To: T10 Technical Committee  
 From: Rob Elliott, HP (elliott@hp.com)  
 Date: 28 June 2002  
 Subject: T10/02-198r4 SAS OOB timing

### **Overview**

The OOB timing requirements need to be more precise, listing the transmit burst time and specifying receiver tolerances. Various other minor changes are also included.

**Figure 1. ~~Phy reset sequence~~ OOB signal generation-transmission and detection**

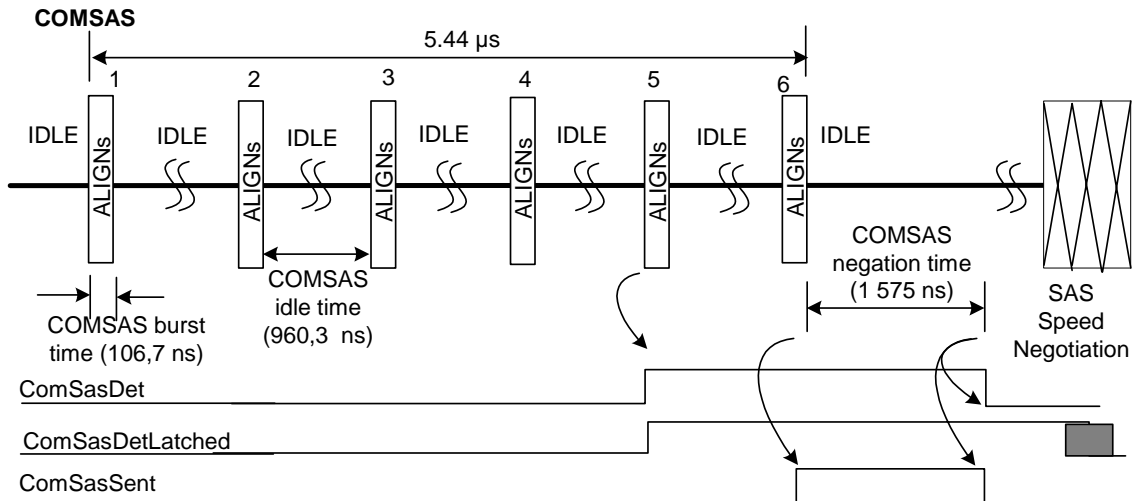
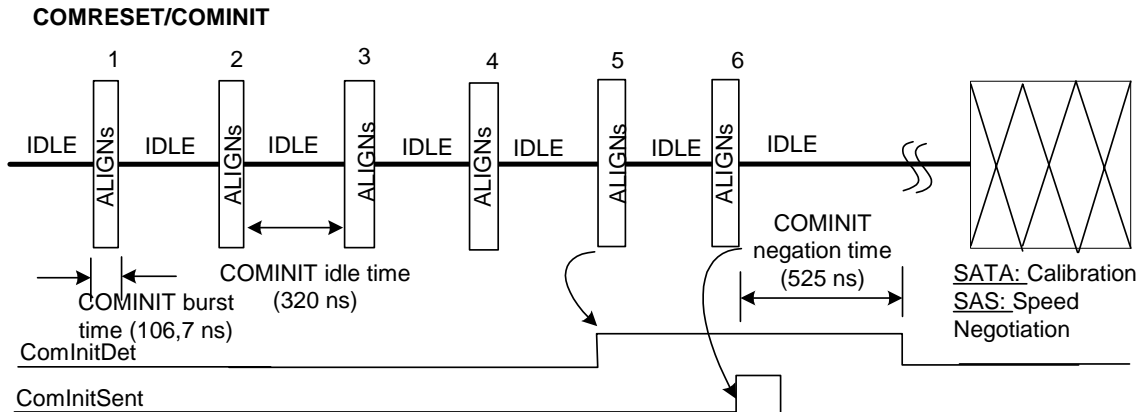
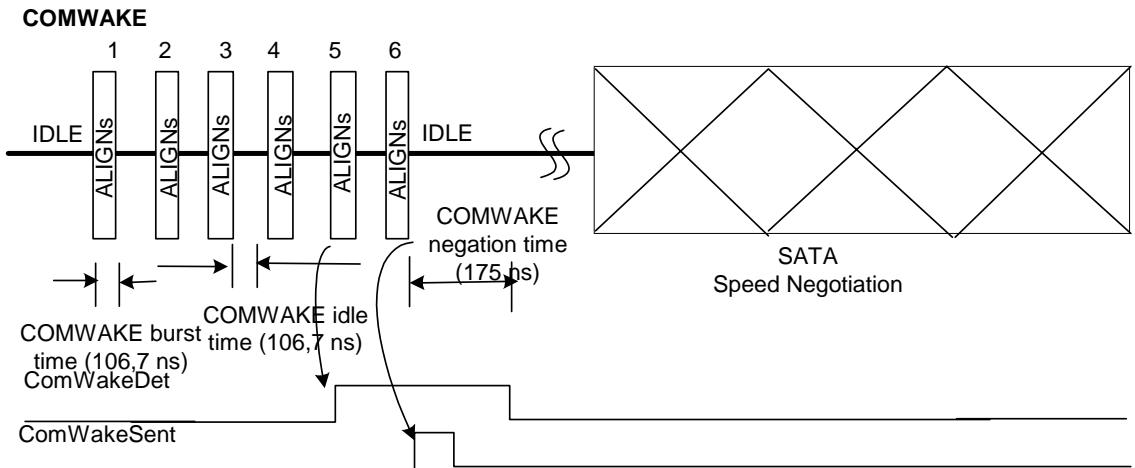
Figure 1 illustrates the timing required for the generation and detection of all the SAS OOB signals. The signals labeled ComXxxDet and ComXxxSent (where Xxx is Wake, Init, or Sas), are inputs to the SAS phy **Initialization layer** state machine. ComXxxDet is an output from the OOB detection circuitry that indicates the detection of an incoming COMINIT, COMWAKE, or COMSAS **sequencesignal**. ComXxxSent is an output from the OOB generation circuitry that indicates that a burst of six COMWAKE, COMINIT, or COMSAS **sequences-signals** has been output onto the link.

**To send an OOB signal, a transmitter shall send the OOB signal at least six times. A receiver shall detect an OOB signal after receiving it at least four times. It shall not detect the same signal again until it has detected another OOB signal or an OOB signal negation time.**

**Figure 36. SAS-to-SAS phy reset sequence**

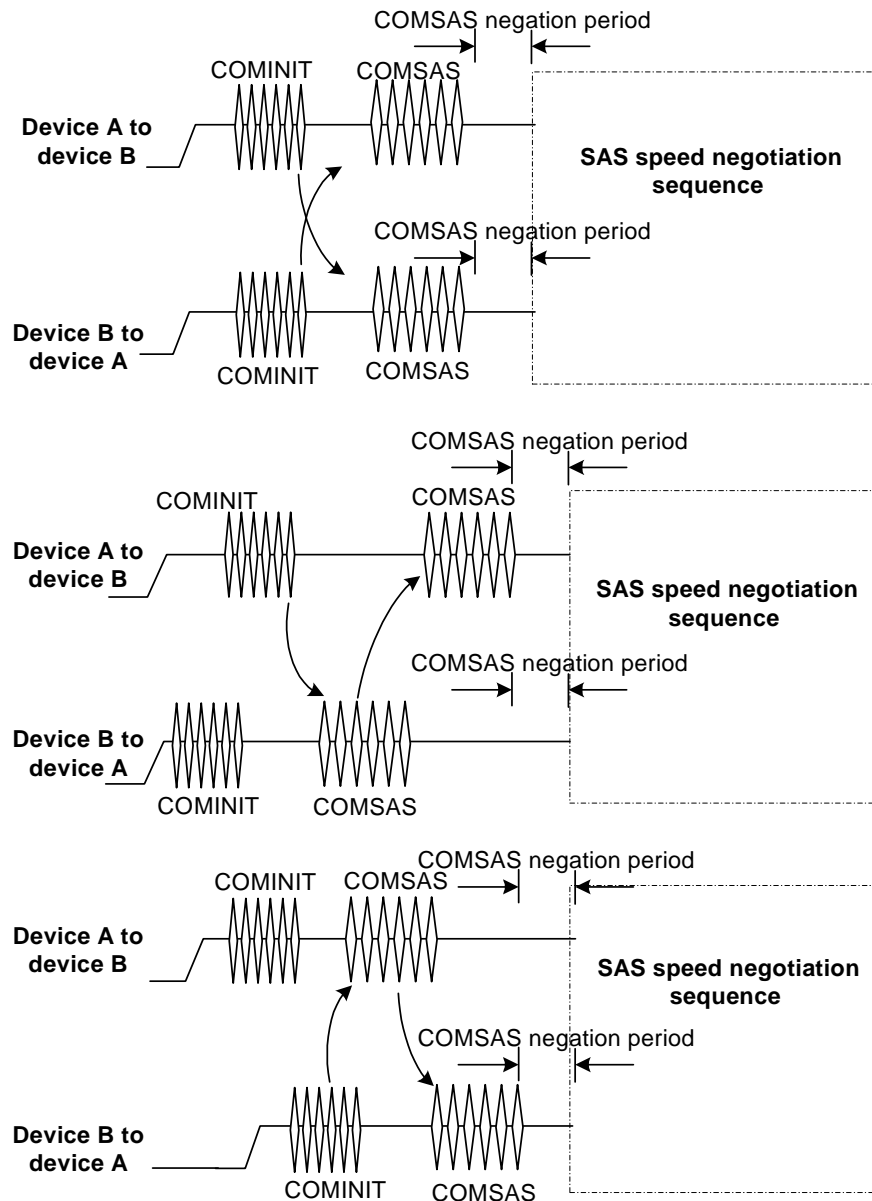
Figure 36 illustrates several different ~~power-up~~ sequences based on whether ~~one a~~ SAS phy powers up before, after, or at the same time as the SAS phy to which it is attached.

**Figure xx. SAS speed negotiation sequence (G1 only with G1 only)**

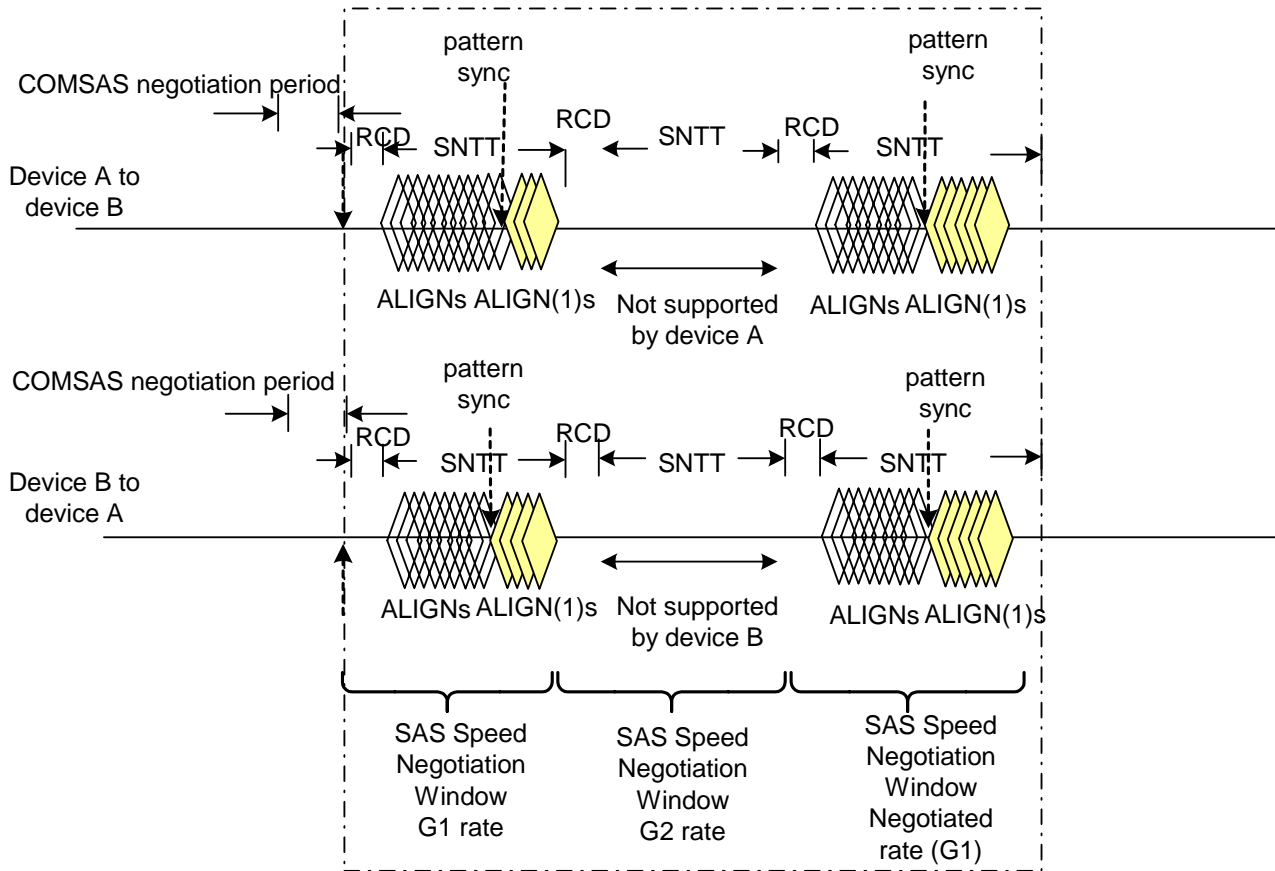
Figure xx shows a speed negotiation between a SAS device A that supports only the G1 link rate attached to a SAS device B that only supports the G1 link rate. They both run the G1 time window (valid) and the G2 time window (invalid), then select G1 for the negotiated rate time window.

Figure 37. SAS speed negotiation sequence (example 1-G1, G2, G3 with G1, G2)

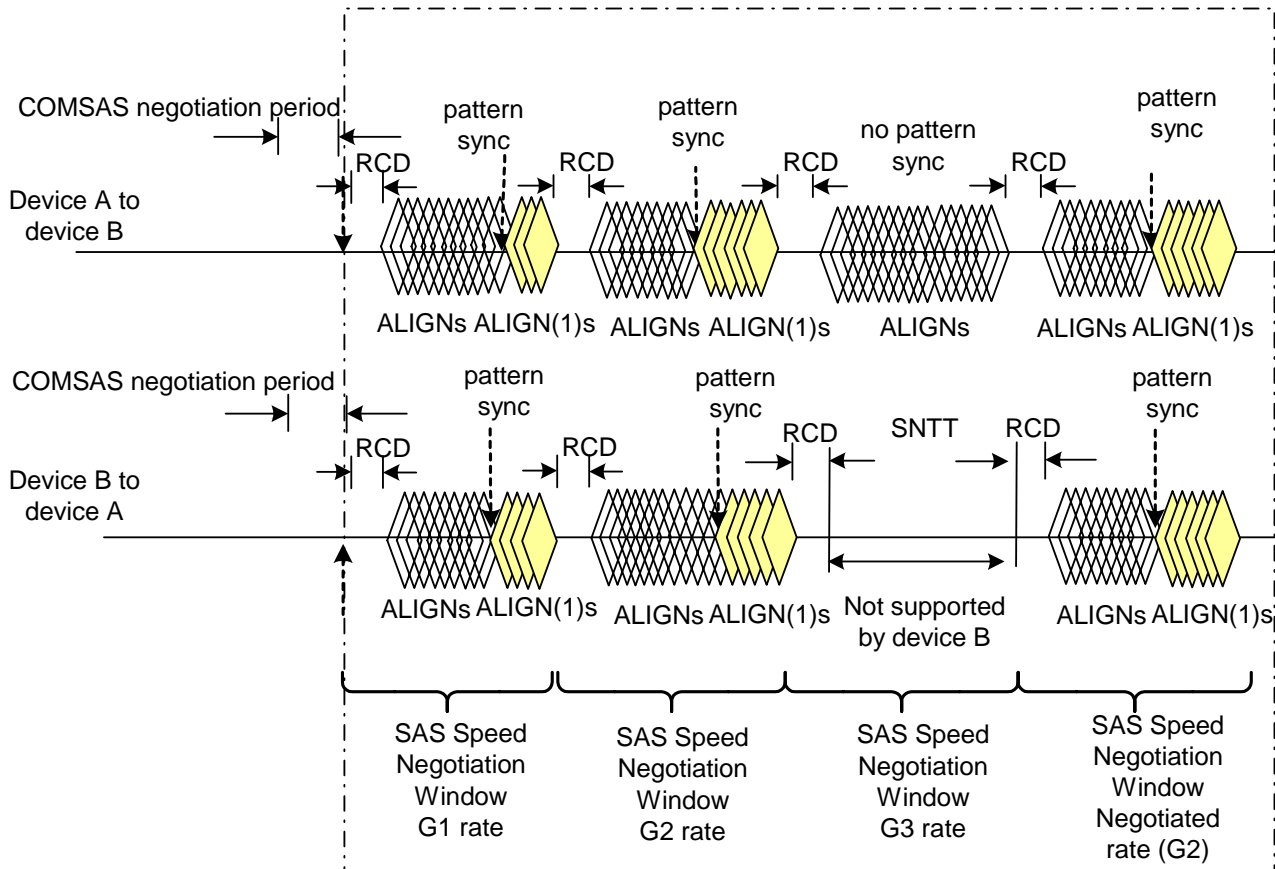
Figure 37 shows a speed negotiation between a SAS phy-device A that supports speeds-G1 thru G3 link rates attached to a SAS phy-device B that only supports speeds-G1 and G2 link rates. They both run the G1 time window (valid), the G2 time window (valid), and the G3 time window (supported by device A but not by device B, so invalid), then select G2 for the negotiated rate time window.

**Figure 38. SAS speed negotiation sequence (example-2G1, G2, G3 with G2 only)**

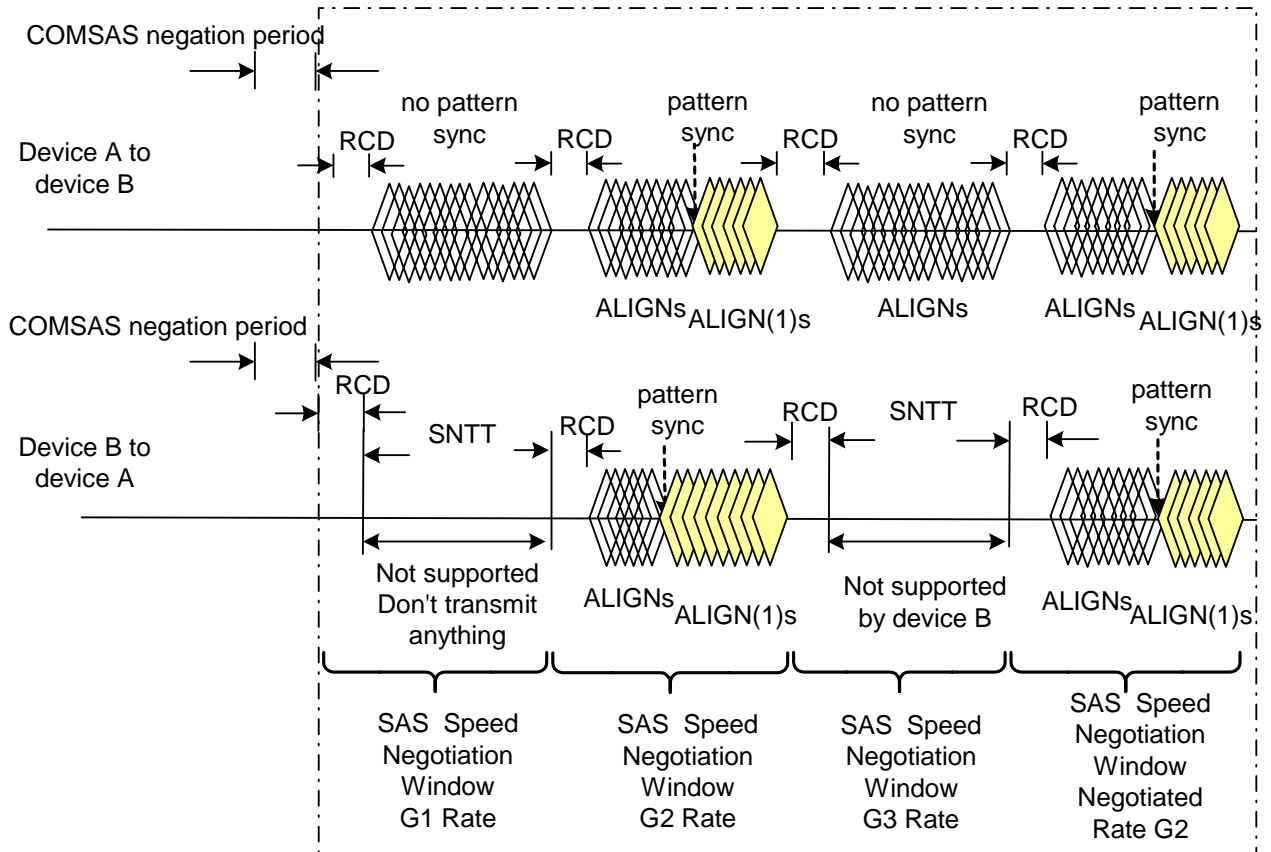
Figure 38 shows speed negotiation between a SAS device A that supports G1 thru G3 link rates and a SAS device B that only supports the G2 link rate. They both run the G1 time window (supported by device A but not by device B, so invalid), the G2 time window (valid), and the G3 time window (supported by device A but not by device B, so invalid), then select G2 for the negotiated rate time window.

Figure 39. SAS speed negotiation sequence (example 3G1,G2,G3 with G1,G2 and failure)

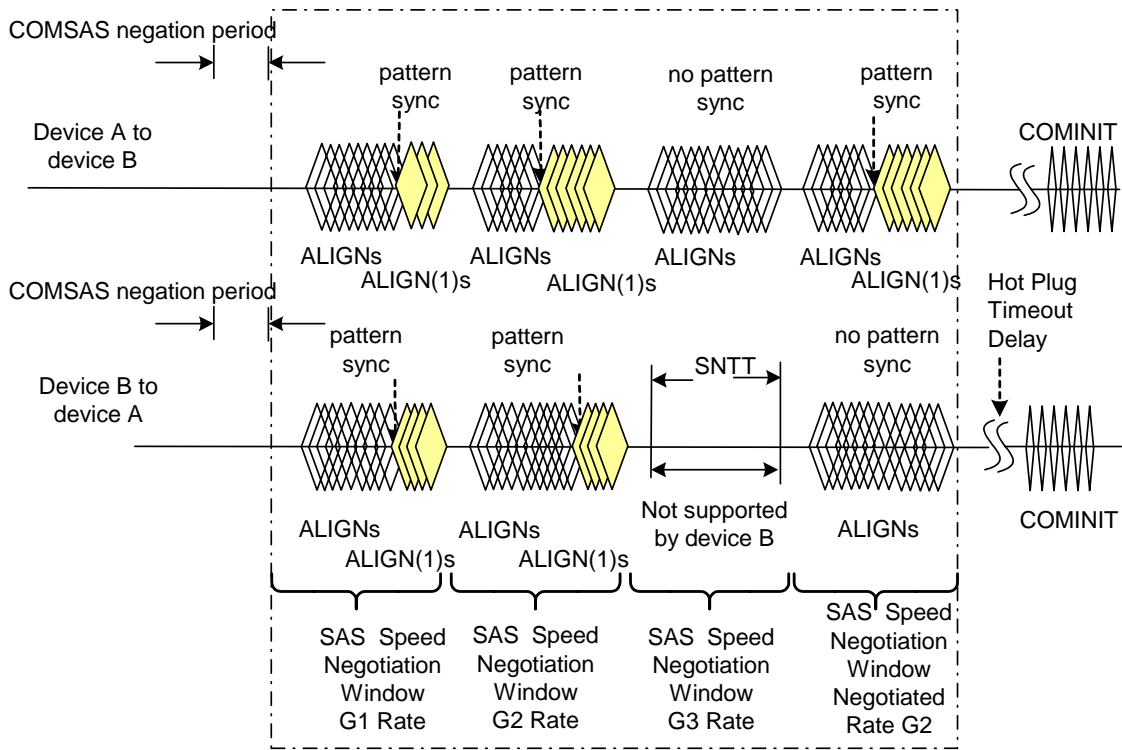
Figure 39 shows the same speed negotiation sequence as in Figure 37, except for some reason, one of the SAS device's PLLs does not obtain ~~pattern\_dword~~ synchronization and detect ~~ALIGNs~~ during the final speed negotiation window. If this occurs, the handshake is not complete and the OOB sequence shall be retried starting with COMINIT, forcing the ~~link-phy~~ to retry the whole reset sequence.
